Re: LETTER DATED JUNE 15, 1976 FROM MR. A. MARTIN
949 E. 24TH AVENUE, VANCOUVER
VEHICULAR CROSSING TO A DWELLING AT 4050 PRICE

ITEM	20
MANAGER'S REPORT NO.	44
COUNCIL MEETING	June 28/76

RE: 4050 PRICE STREET

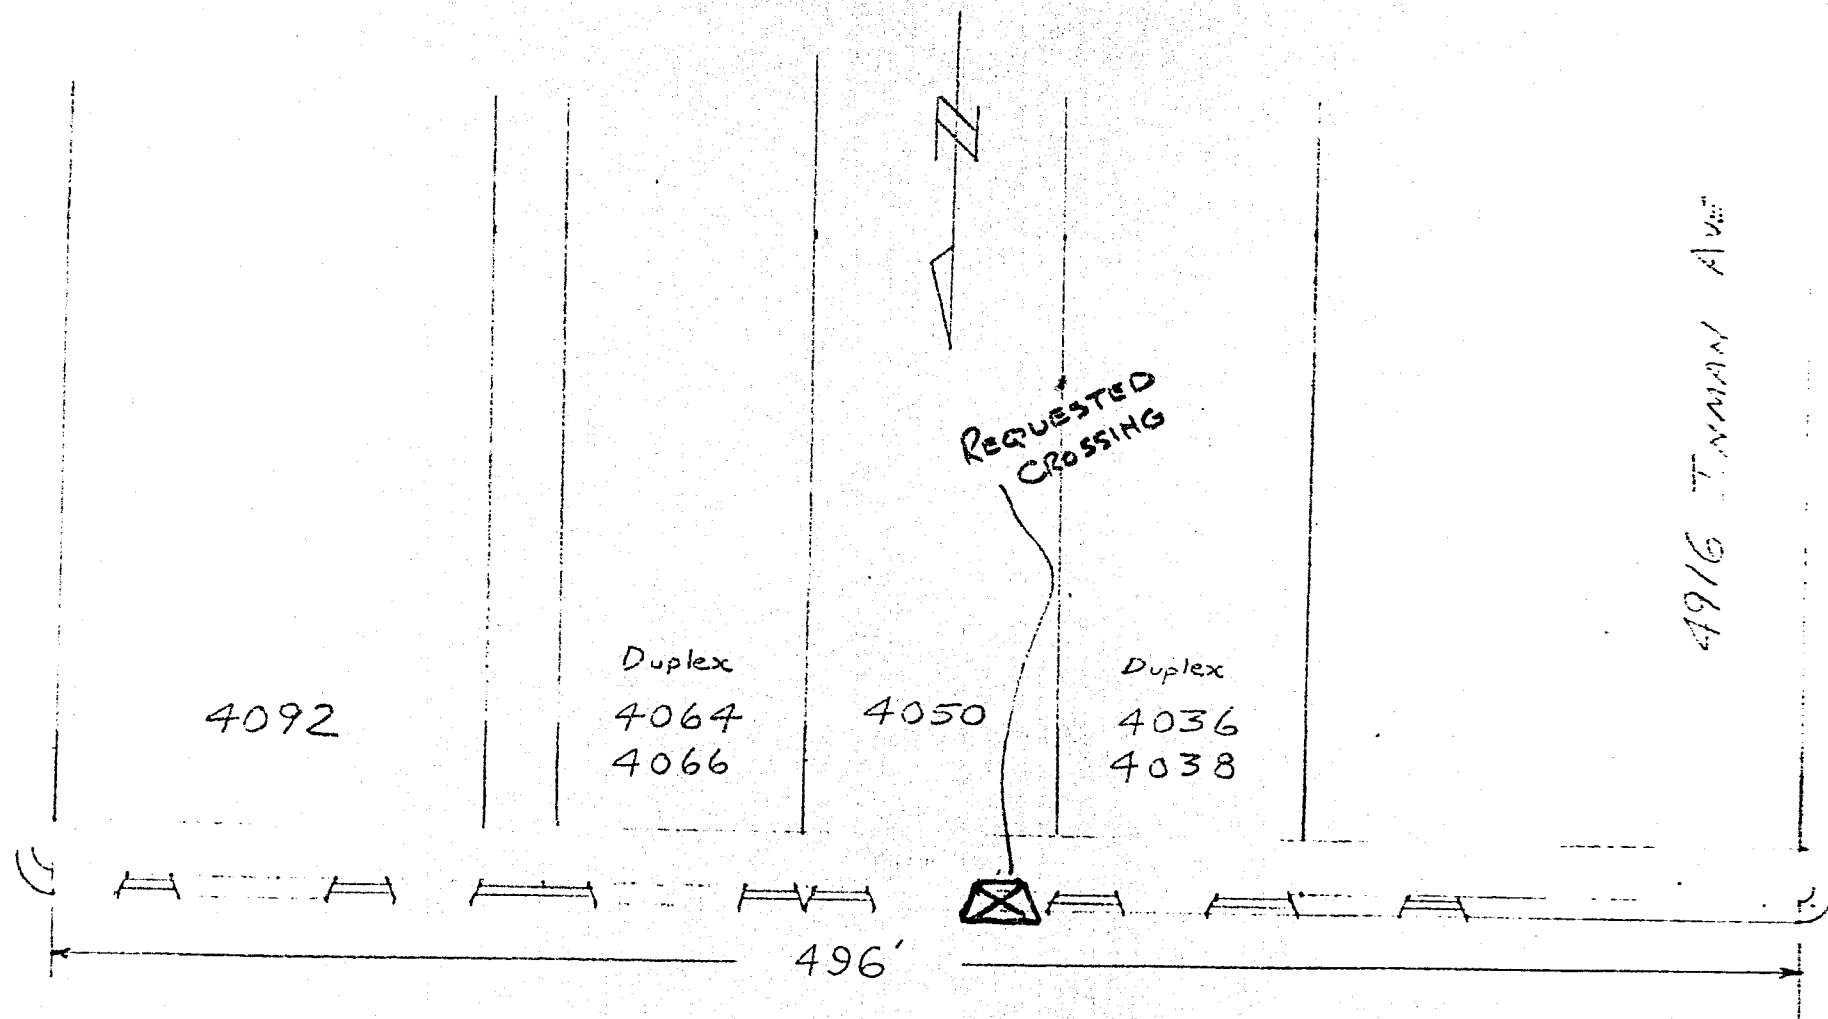
When Mr. Martin made application for a new crossing on the west side of his property he was advised that he would have to pay for the removal of the existing crossing on the east side that would then be redundant. When Mr. Martin advised us that he wished to retain this existing crossing to provide a loop driveway, he was informed that under our existing sidewalk crossing policy his development did not meet the requirements for such treatment.

The request for a loop driveway by Mr. Martin was refused under Section 7 of the attached policy and the fact that he is building a single family home not a duplex.

Sidewalk crossings constitute 172 feet or 35% of curb face

1. THAT Council reaffirm its approval of its past decisions on loop driveways as contained in Appendix "B" of the crossing manual; and
2. THAT a loop driveway for 4050 Price Street be refused; and
3. THAT Mr. Martin be sent a copy of this report.
